Title			ISC System Wiring Diagram		
Size	Number			Revision	
B	D1900511			V5	
Date:	2/25/2021	Sheet	1 of 38		
File:	C:\Users\...\ISC_C1_SH1.SchDoc	Drawn By:	Filiberto Clara

ISC System Wiring Diagram

ISC-C1 Rack

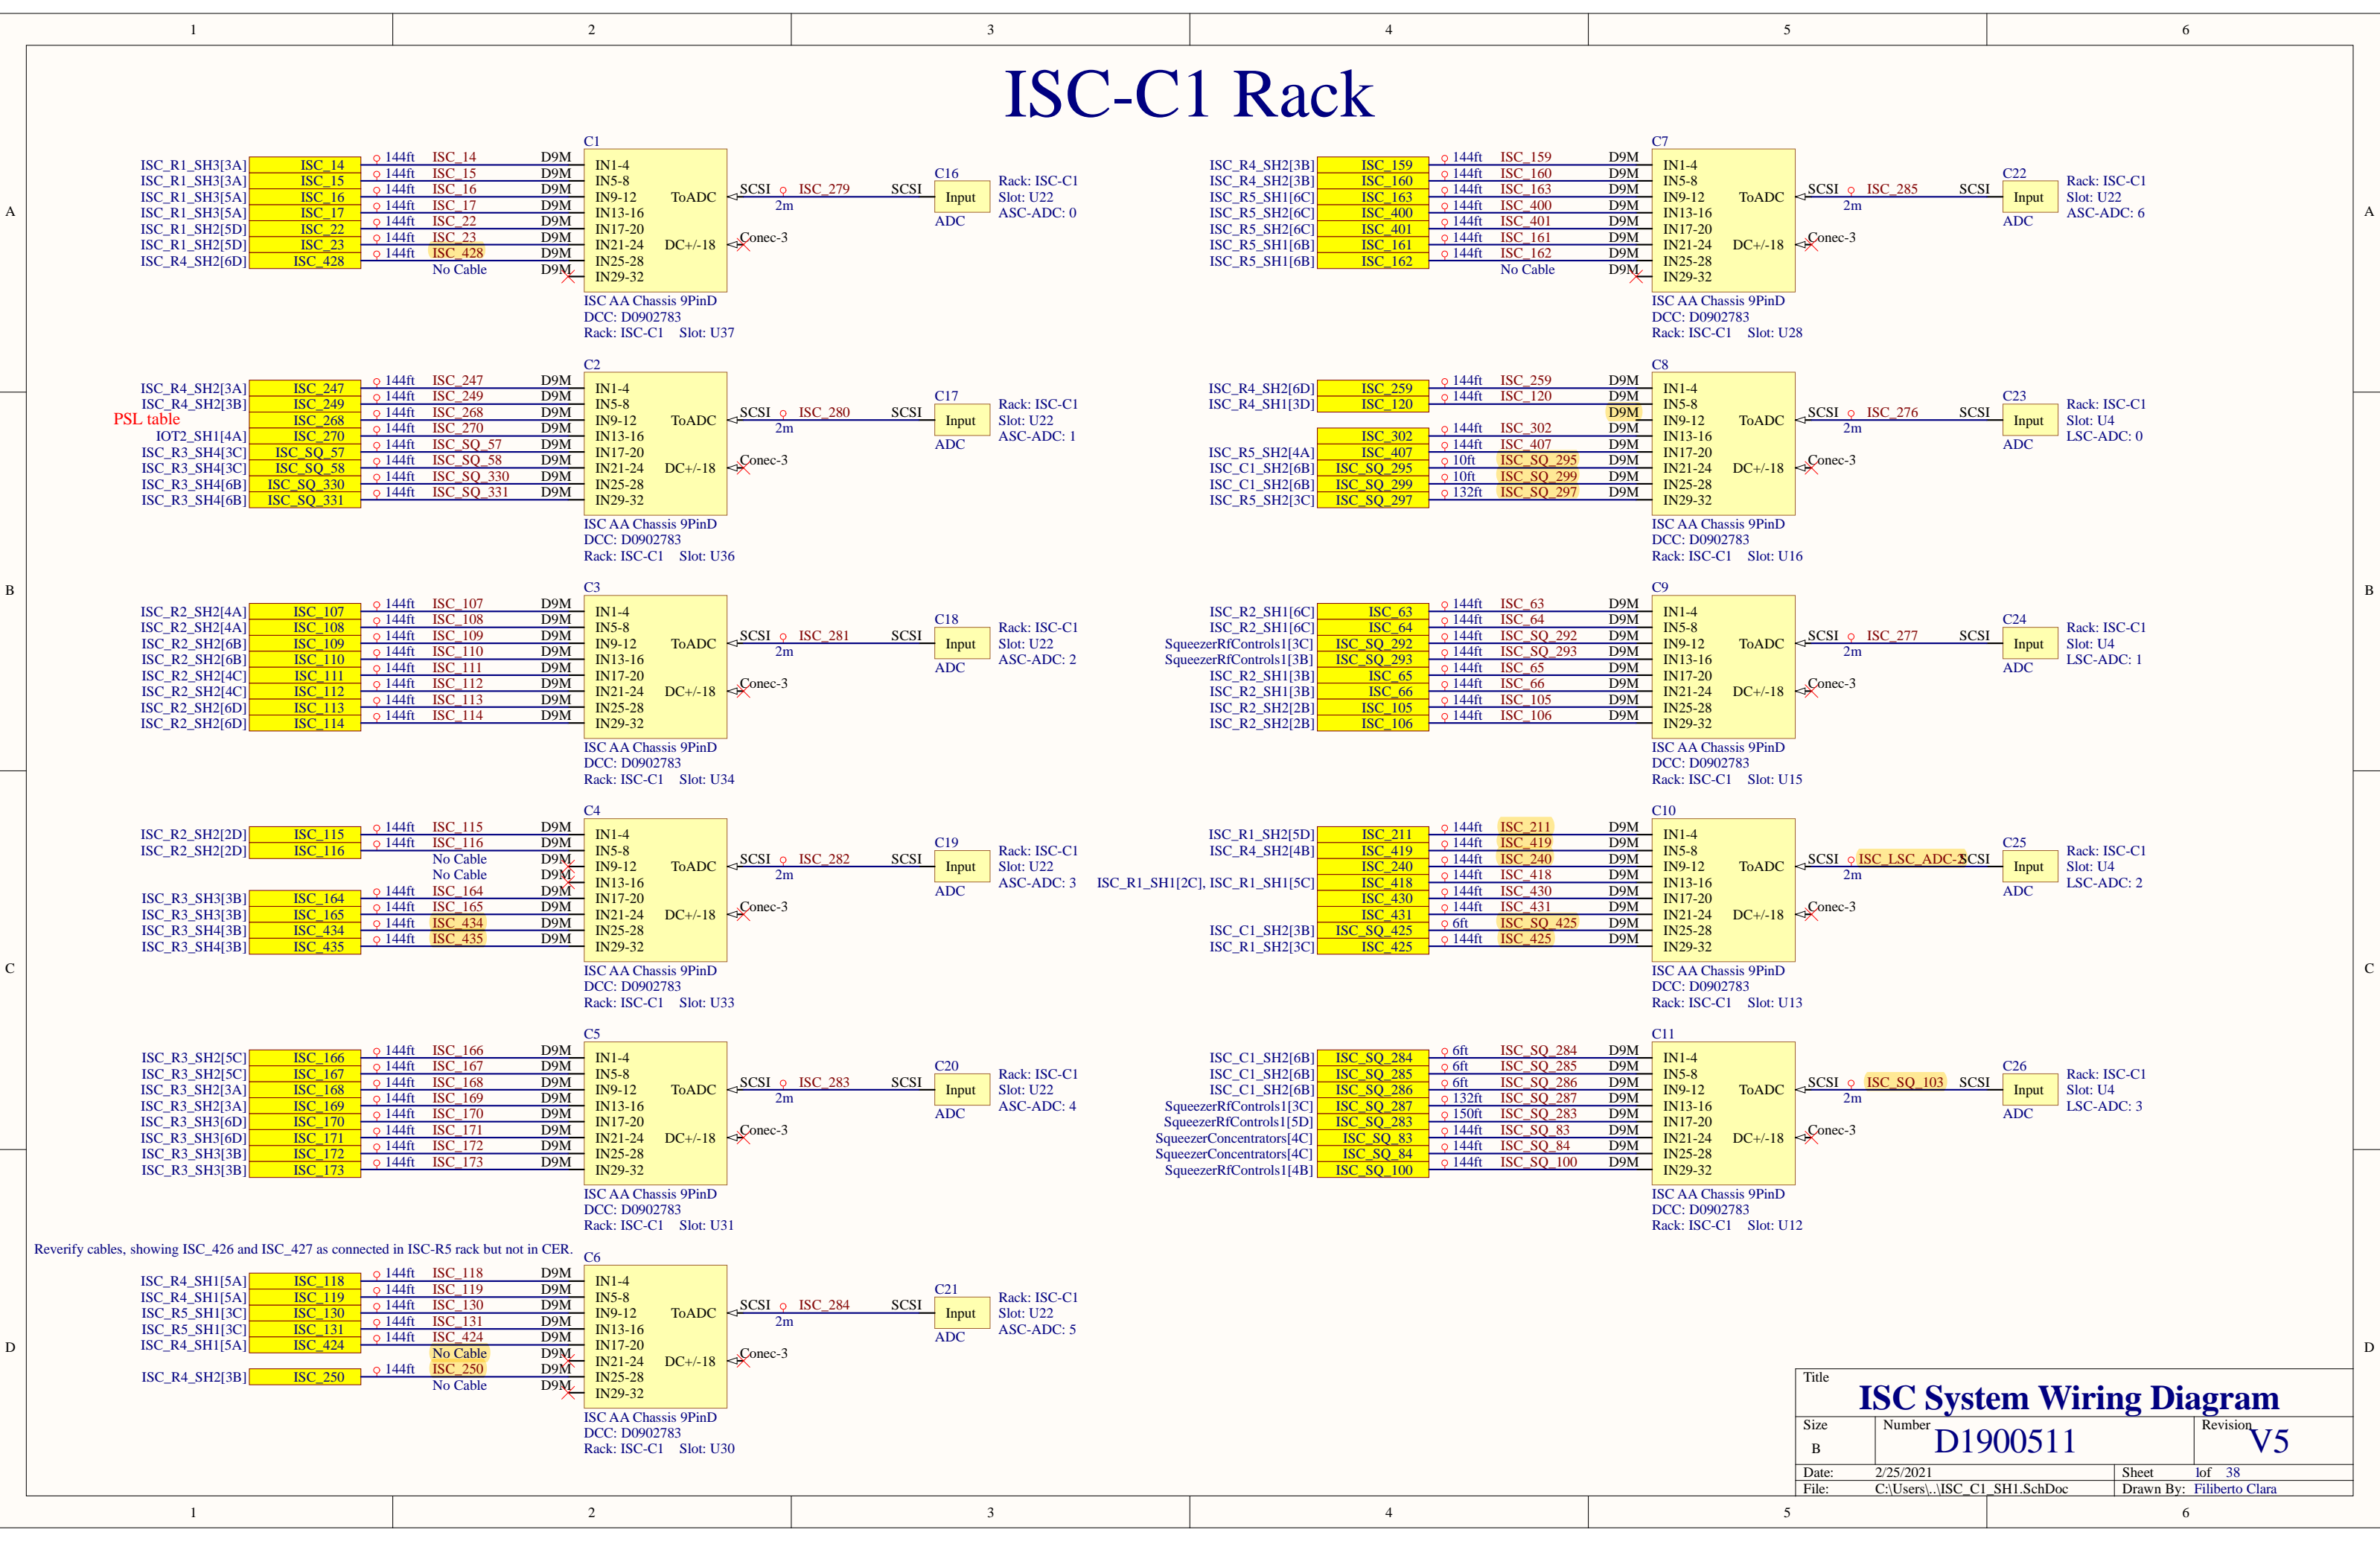
Reverify cables, showing ISC_426 and ISC_427 as connected in ISC-R5 rack but not in CER.

ISC-C2 Rack

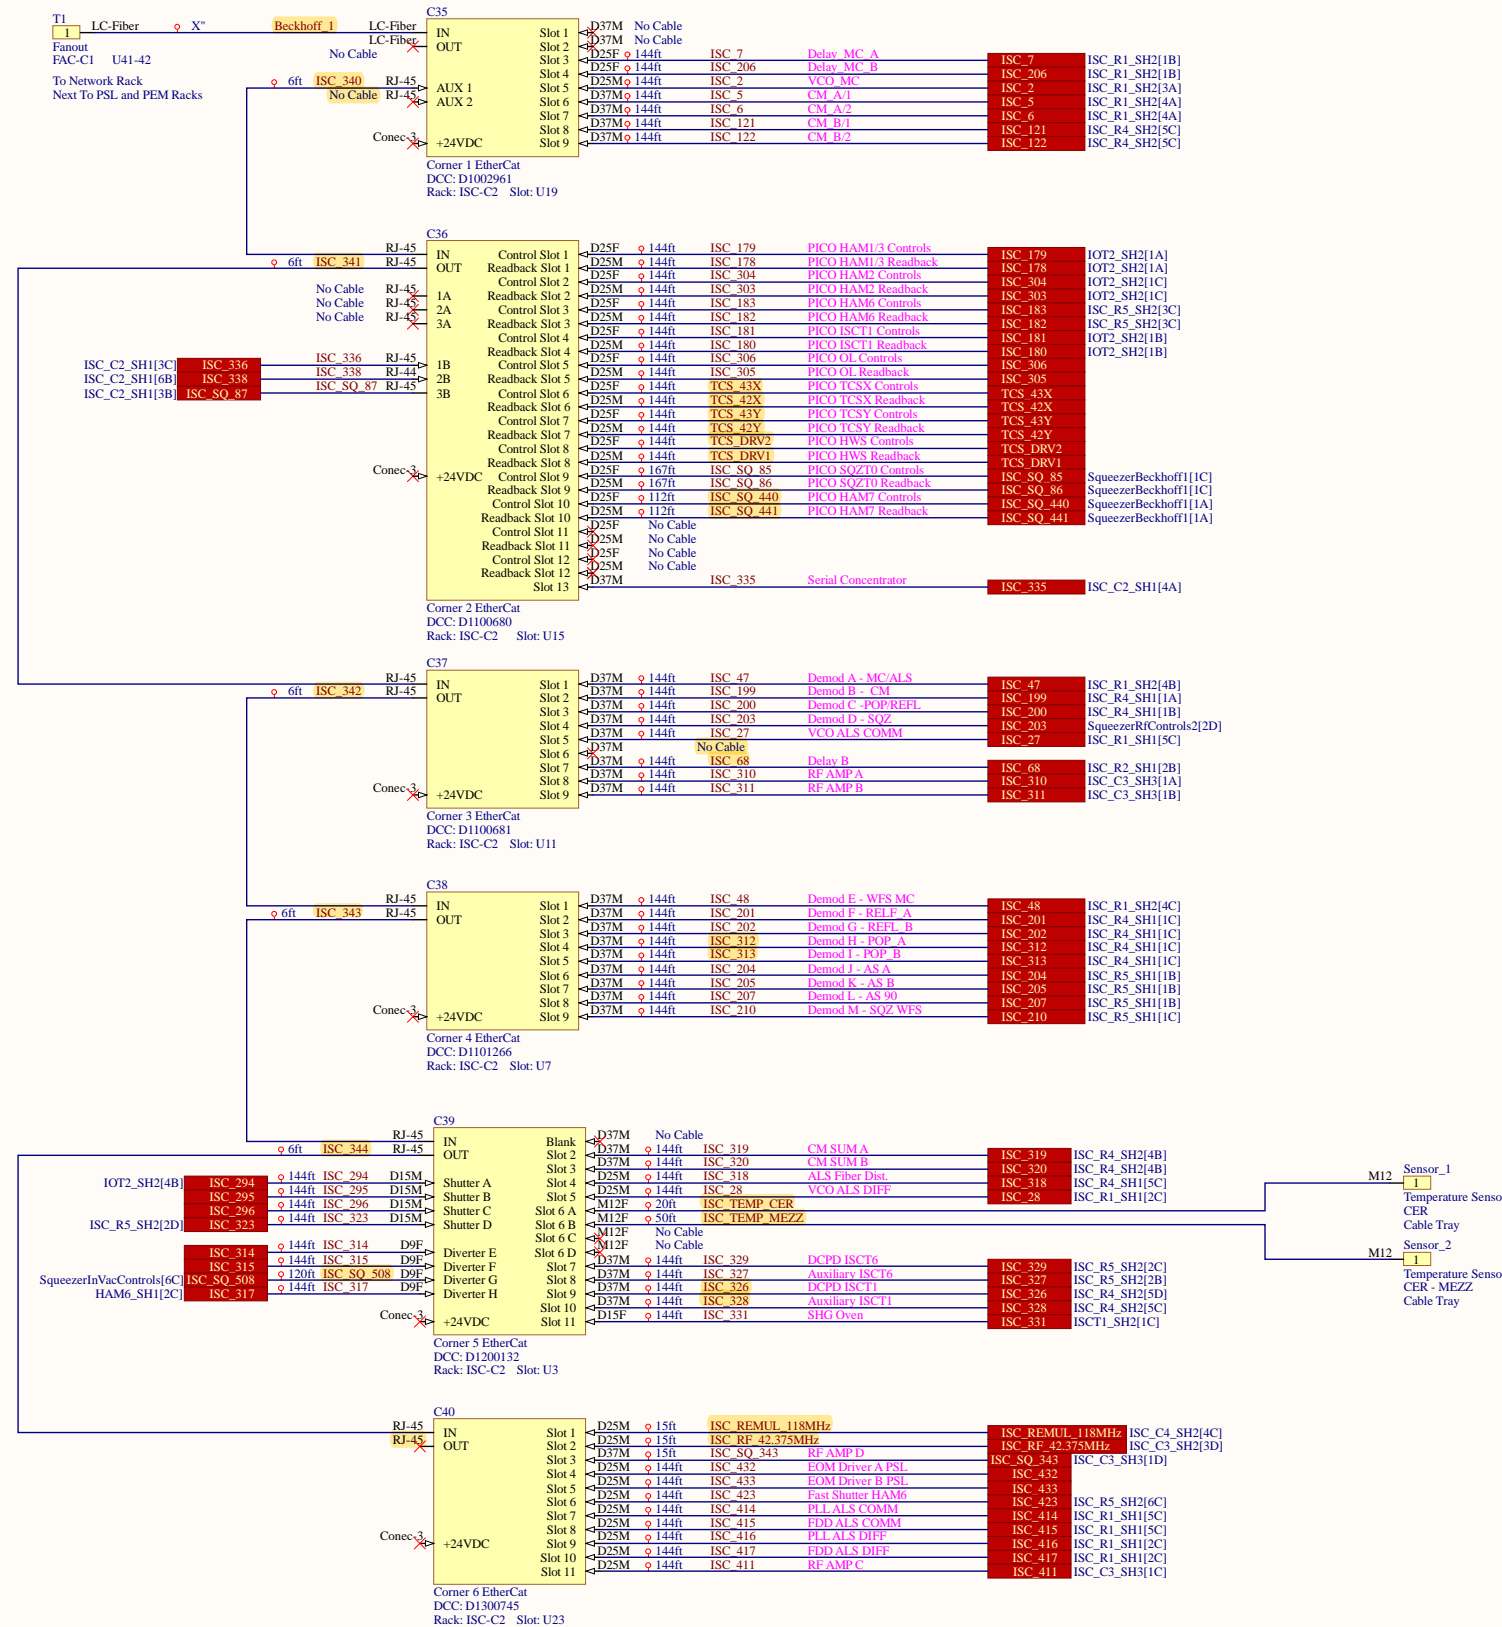
SQZ Drawing has Diff Mix 3.125MHz going to slot 2 need to verify

ISC-C3 Rack

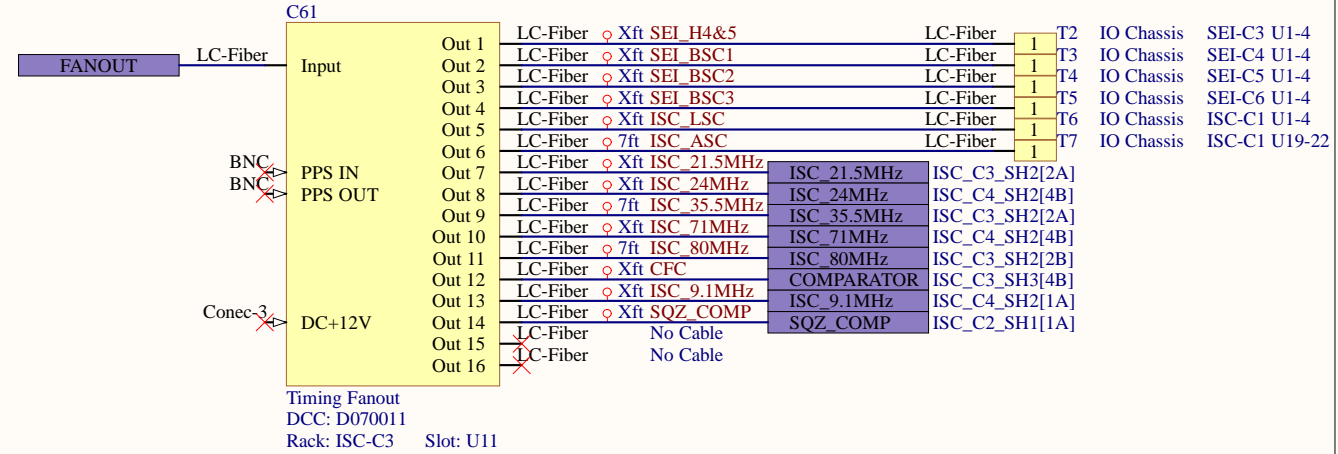
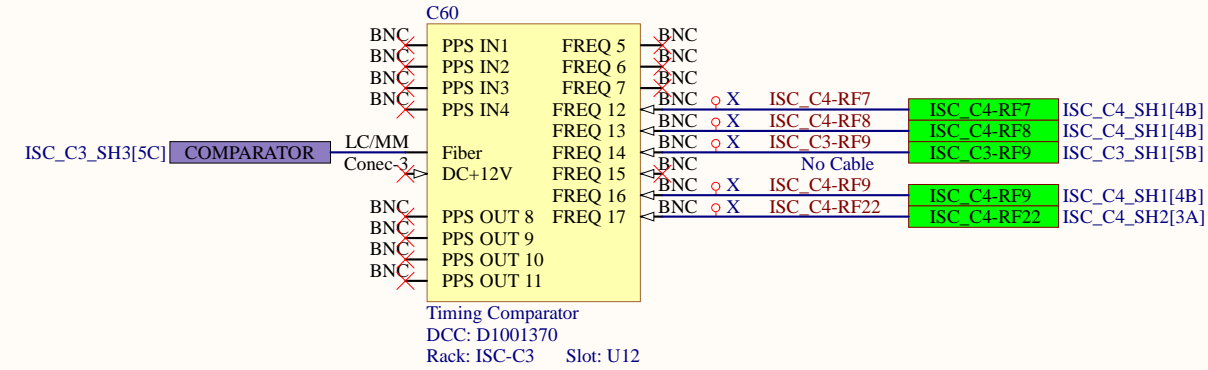
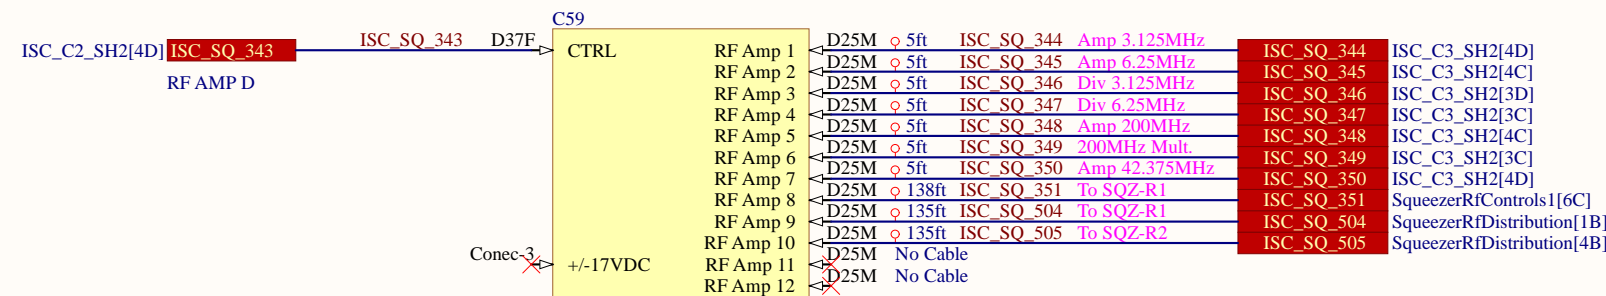
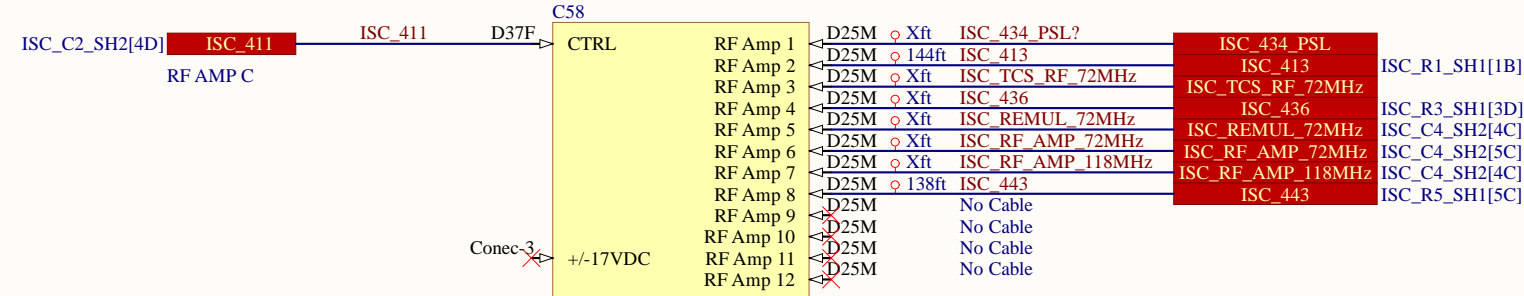
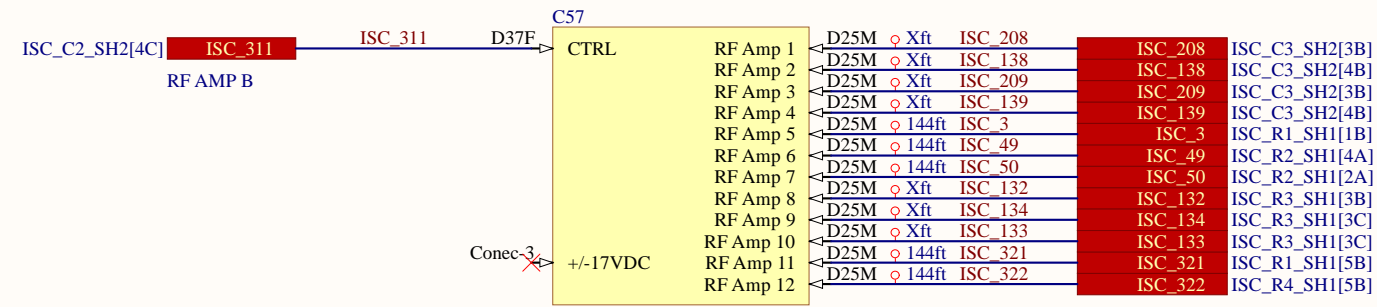
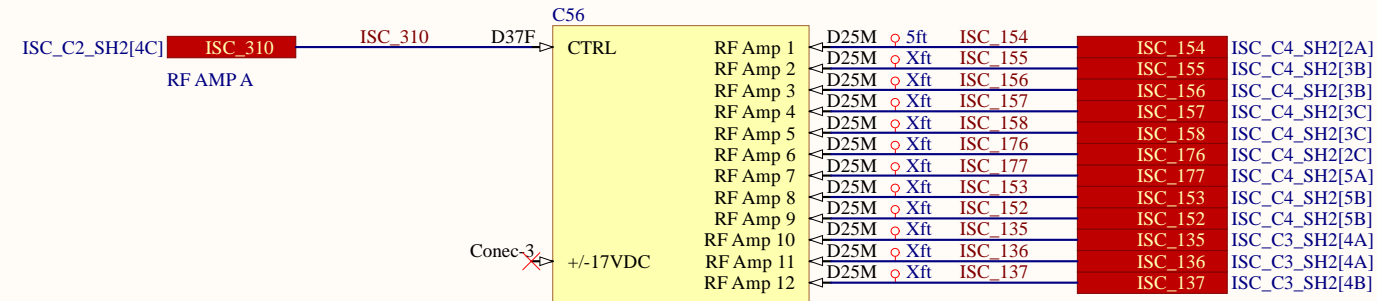
Need Locations of other ends.
SEI IO Chassis

RF Patch Panel 12

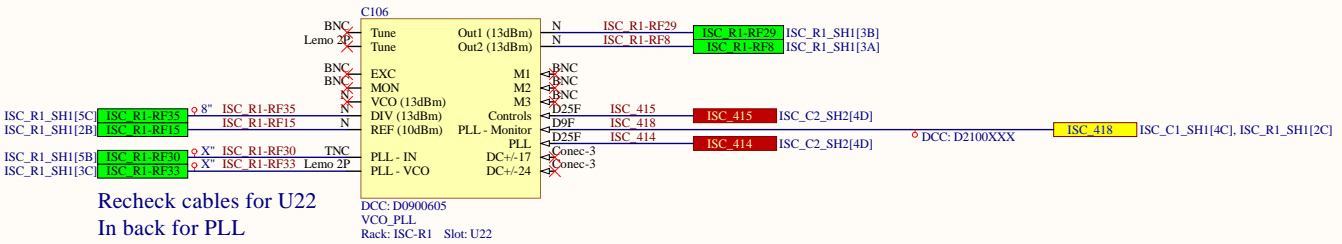
Recheck cables for U22
In back for PLL
